INSTALLATION MANUAL

REF NO.	BT02073A
DATE	Feb. 19, 2003
(C) Page 1 of 48

This INSTALLATION MANUAL supersedes the previous issue No. BT02073 dated Jan. 6, 2003 which should be discarded.

SUBJECT: INSTALLATION PROCEDURE OF VHMS ON HD465-7/HD605-7

Fig. 2-1 Monitor panel replacement procedure

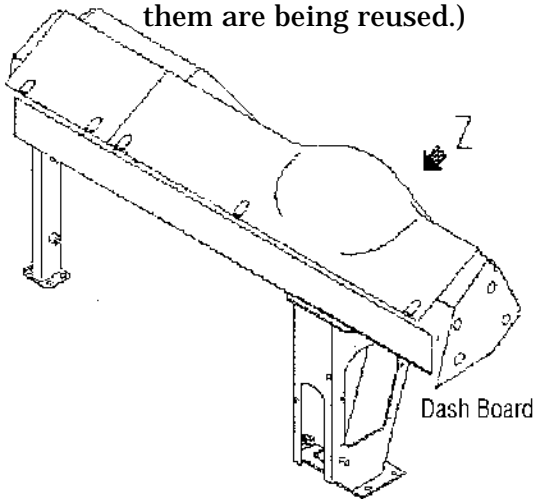
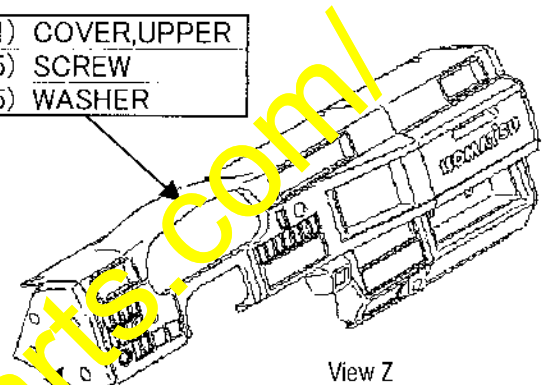
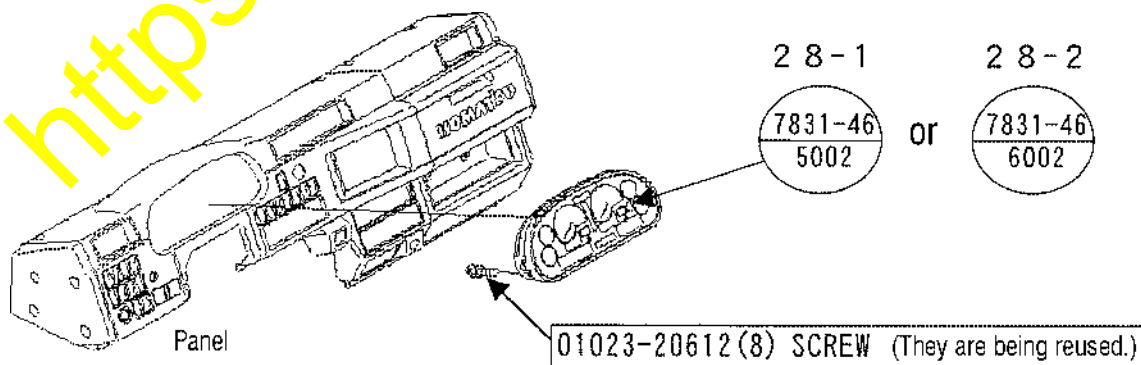
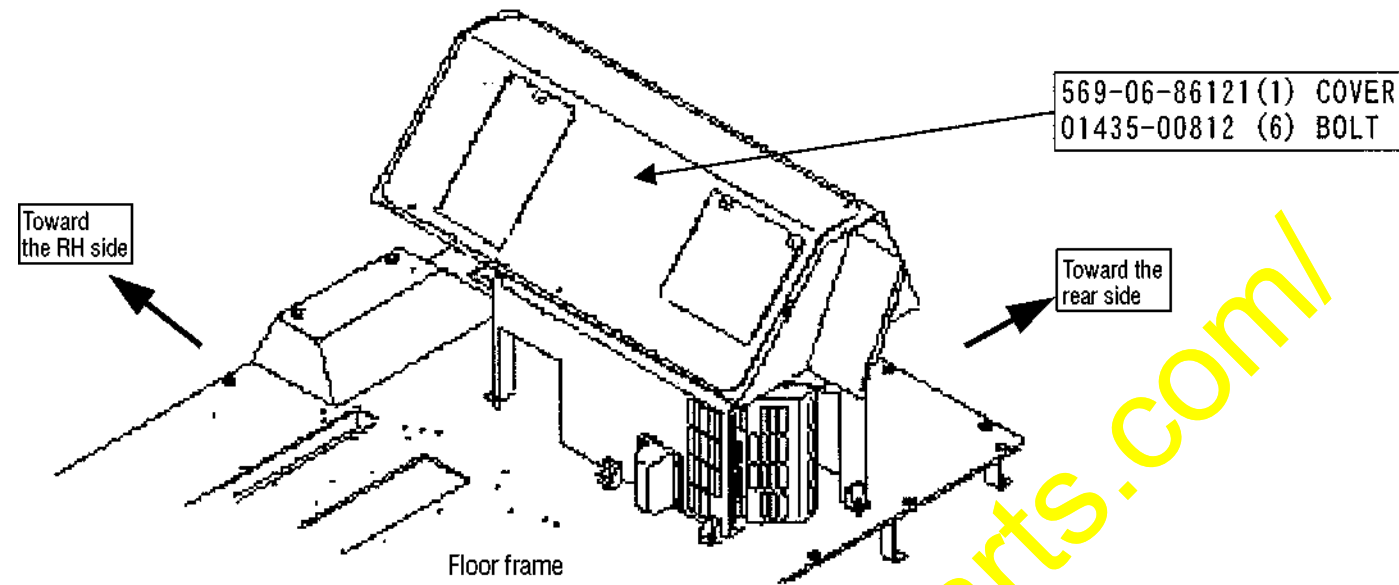
7059  7024

In case of Serial No. ~~7052~~ and after of the HD465-7 and Serial No. ~~7024~~ and after of the HD605-7, this replacement work is not necessary since the new monitor panel applicable to the VHMS has been already installed to standard spec. vehicles.

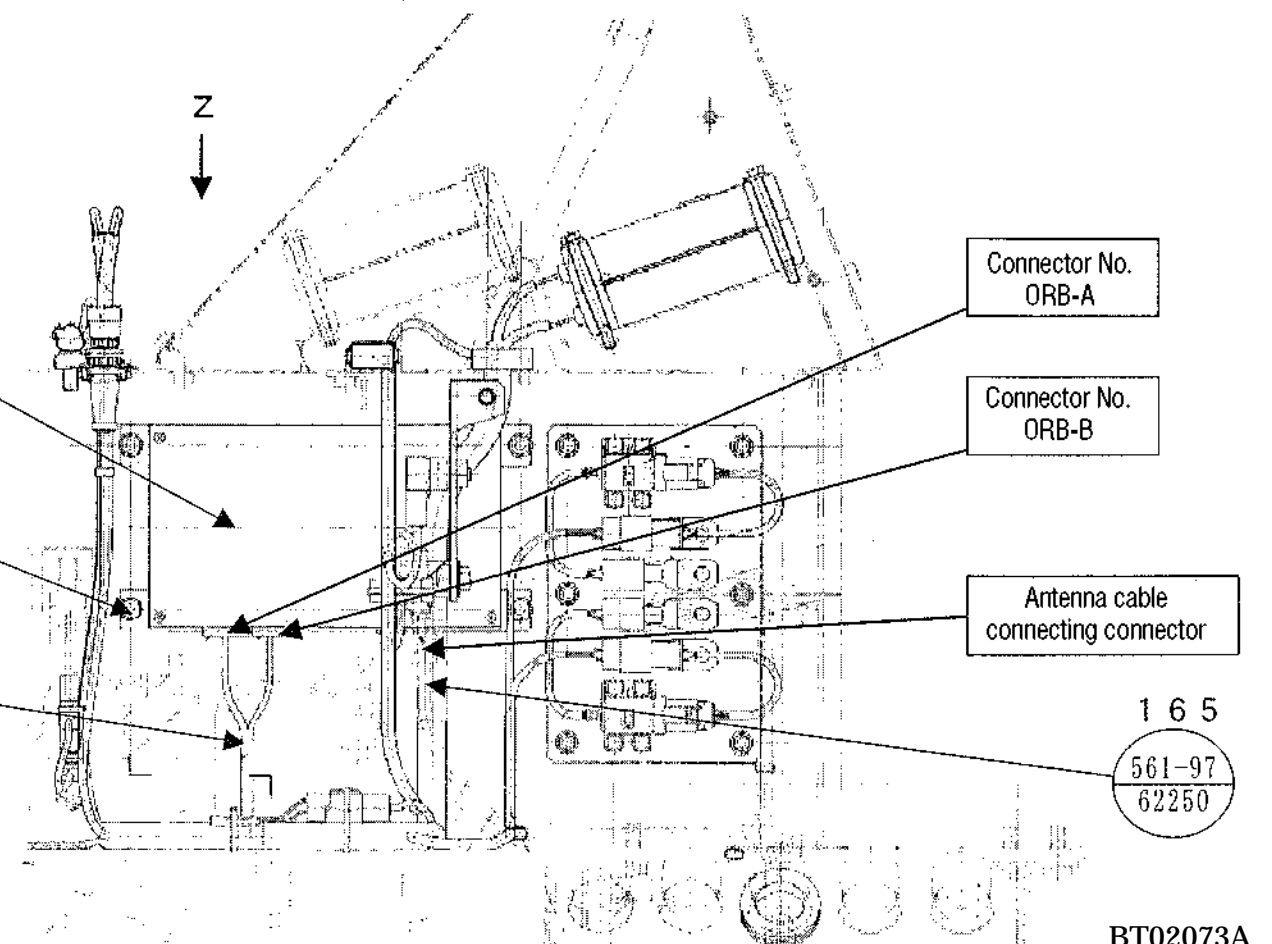
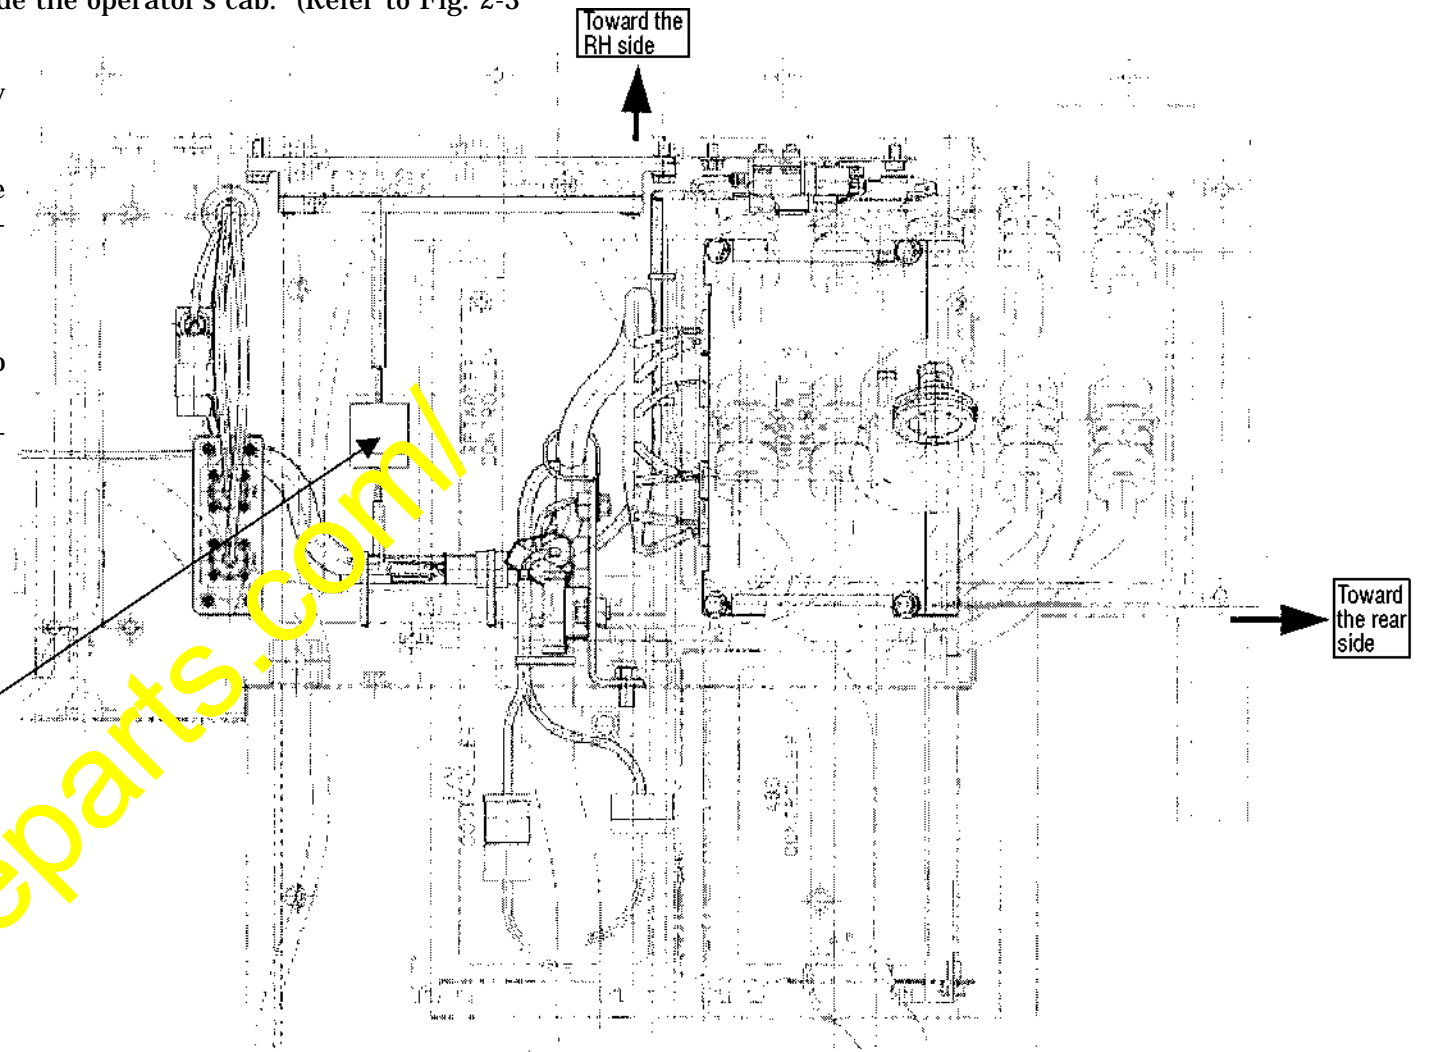
- (2) Install the ORBCOMM controller, Item No. Δ 160 (7826-12-2200) to the existing bracket (569-54-85711) by use of the bolt, Item No. 161 (01010-80816) and the washer, Item No. 162 (01643-30823).

Δ 160
~~7826-12-2200~~ ~~7826-20-1090~~

162 161
~~01643-30823~~ ~~01010-80816~~
